## 2018 Regional SO<sub>2</sub> Emissions and Milestone Report

Submitted March 2020

As required by the regional haze state implementation plan element for Albuquerque - Bernalillo County ("Regional Haze SIP"), the February 12, 2020 meeting of the Air Quality Control Board ("Air Board" or "Board") provided an opportunity for public comment on the draft 2018 Regional SO<sub>2</sub> Emissions and Milestone Report ("2018 Milestone Report" or "Report"). Ed Merta, staff member for the City of Albuquerque Environmental Health Department ("EHD"), delivered an oral summary of the draft 2018 Milestone Report.

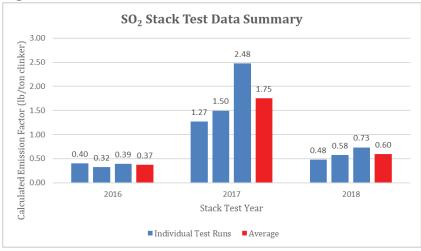
Comments and discussion suggested that GCC's emissions in years prior to 2018 would have been shown to remain constant at levels the same or similar to 2018, i.e. over 100 tons, if the 2018 stack test method had been used in earlier years. The comments suggested that this constant level of emissions was not adequately captured in the emissions inventory process.

As mentioned earlier,  $SO_2$  emissions at the kiln GCC uses to produce cement are variable over time, not constant, due to nature of the kiln's operations. Stack tests to estimate the emissions reflect this variability. Figure C-4, below, illustrates the variability. This figure provides GCC data derived from stack tests for 2016, 2017, and 2018. In each year, GCC performed three 1-hour stack test runs, as required by its permit, and then averaged the result together. This final average is expressed as an emissions factor in pounds of  $SO_2$  per ton of "clinker" produced. Clinker is a type of raw material produced during the manufacturing process that eventually is turned into cement.

Figure C-4 shows that the emission factor derived from stack testing data varies from test to test and year to year. In light of this variability, it isn't accurate to say that GCC's estimated emissions would have remained constant prior to 2018 if a stack test had been used for emissions inventory reports.

In addition, EHD reiterates that in 2015 and in prior years, conducting stack tests at GCC was physically impossible because no stack existed. GCC could only begin stack testing in late 2016.
